CENTER for SCIENCE in PUBLIC PARTICIPATION

October 26, 2020

Linda Jackson, Payette Forest Supervisor
Stibnite Gold Project
500 N. Mission Street, Building 2
McCall, Idaho 83638
comments-intermtn-payette@fs.fed.us

Scope of Review

Figure 6. Tailings tested for acid and neutralization potential. Source: SRK 2017a, Table 3-61

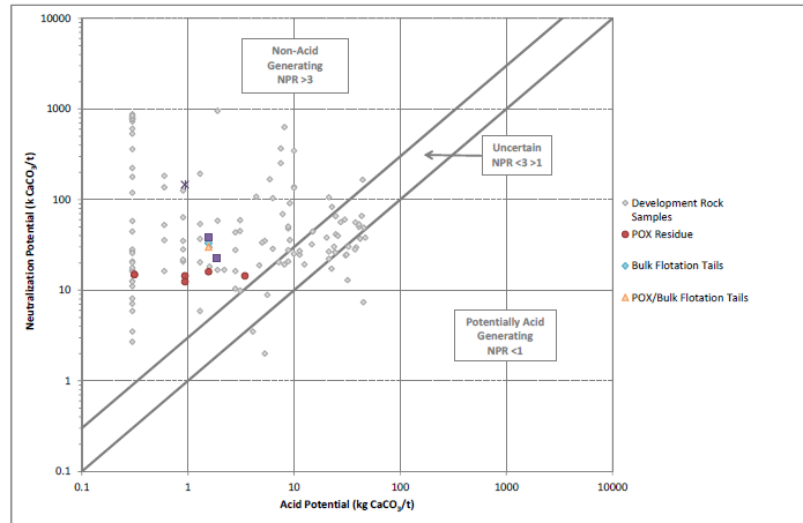
- Although six POX tailings samples went through SPLP, only a single sample of mixed POX and flotation tailings was tested by SPLP.
- Tailings leachate chemistry testing could be improved. Only SPLP tests were done due to a lack of material – why couldn't more material be made available? The MWMP has a liquid to solid ratio of 1:1 and is more representative of arid or semi-arid areas like the Stibnite site.

The tailings samples were submitted for SPLP leach testing, rather than MWMP, due to the limited quantity of tailings material available for testing and the finer grain size. Some of the disadvantages of the SPLP test are the high liquid to solid ratio (3:1) that may result in an underestimate of leachability and grain size reduction may increase reactivity. The MWMP and HCT leachate chemistry for the tailings and development rock is therefore not directly comparable. The SPLP results only provide a qualitative evaluation of constituents that could occur at concentrations above the water quality criteria and are not considered to be conclusive or to represent actual predictions of water quality.⁶⁶

Figure 7. Waste rock and ore acid and neutralization potential. Green dots show waste rock material chosen for HCTs; the black dot is an ore sample chosen. No surface samples were chosen. *Source: SRK 2017 baseline Fig. 3-8*

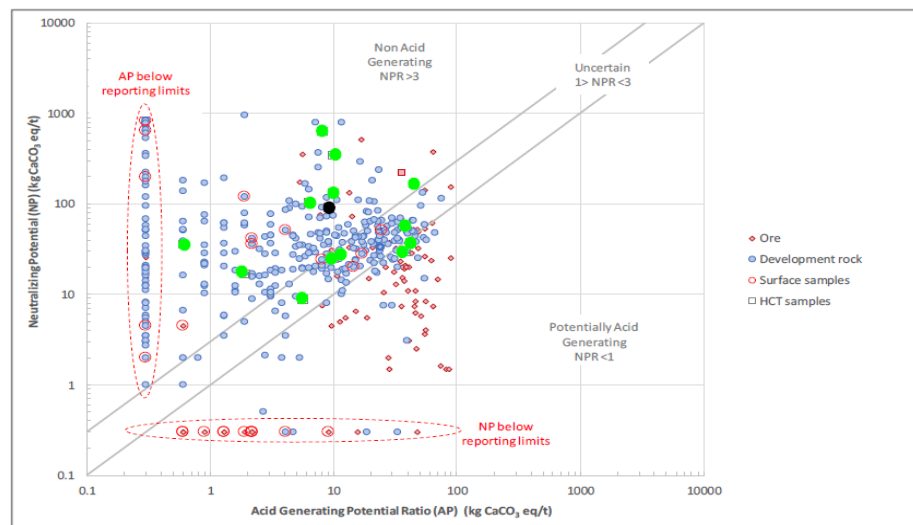
- Only a single sample of ore-grade material went through HCTs (Fig. 7). The ore-grade sample was chosen from non-acid generating material, when most ore-grade material falls in the potentially acid generating area. Including them in HCTs would provide information on the rates at which analytes may leach from this material, which will be present on pit walls, tunnels if underground mining occurs, and potentially in waste rock an tailings.

Figure 8. Model of future contaminant concentrations based on past precipitation. (Upper) Annual average precipitation data applied in predictive SWWC model. (Lower) Predicted future arsenic concentrations at HF WRF. *Source: SRK 2018c Fig 4-9, Fig 4-17, and others.*

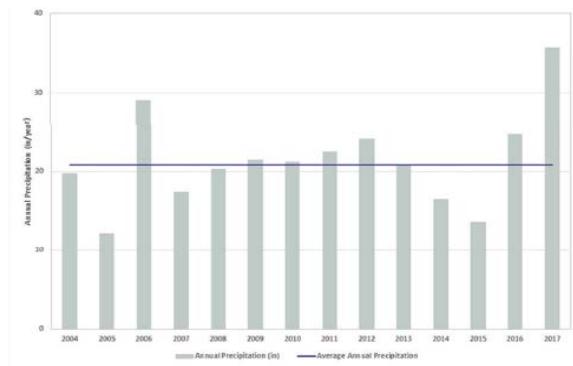
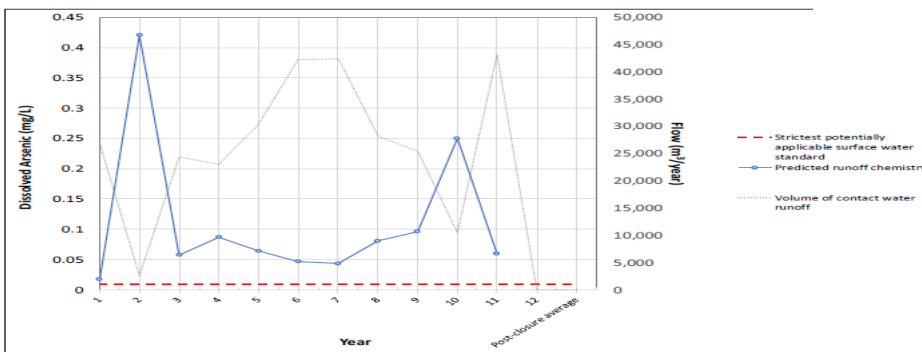
- Applying annual precipitation averages for years 2004-2017 directly to mining years provides insufficient results. As applied in the model, 2005 was a low water year, so predicted stream water quality in Mine Year 2 reflects a low water year (Fig. 8). This is inappropriate for understanding environmental impacts. Precipitation should be applied on a monthly or weekly basis and inform predictions for water quality at stream nodes on a monthly basis.

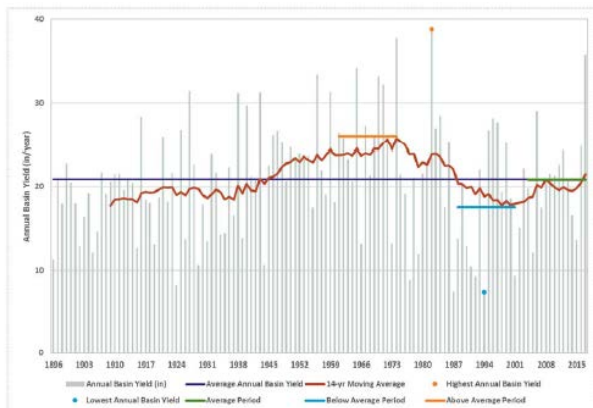
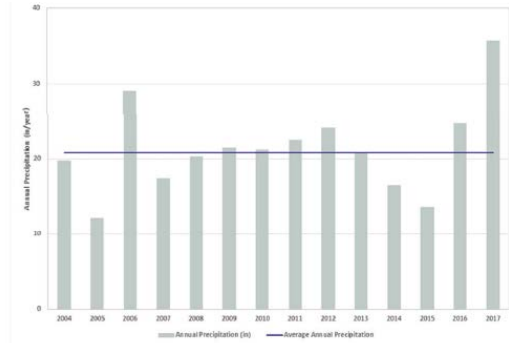
- A wider range of precipitation needs to be considered in bounding uncertainty (Fig. 10).
- There is uncertainty associated with future wildfires, and their effect on soil (soil chemistry, ability to hold moisture, slumping and landslides) and water quality (increase in mercury from air deposition and ash, turbidity, increased dissolved organic carbon concentrations in streams, which can change the bioavailability of certain metals, etc.). Wildfires may increase in frequency and intensity and this type of hazard is one reason why uncertainty analyses are necessary, to acknowledge that water quality is not going to neatly follow models, particularly when looking out 100 years or more and that in fact a wide range of natural changes may add or subtract from a wide range of reasonable model outcomes.
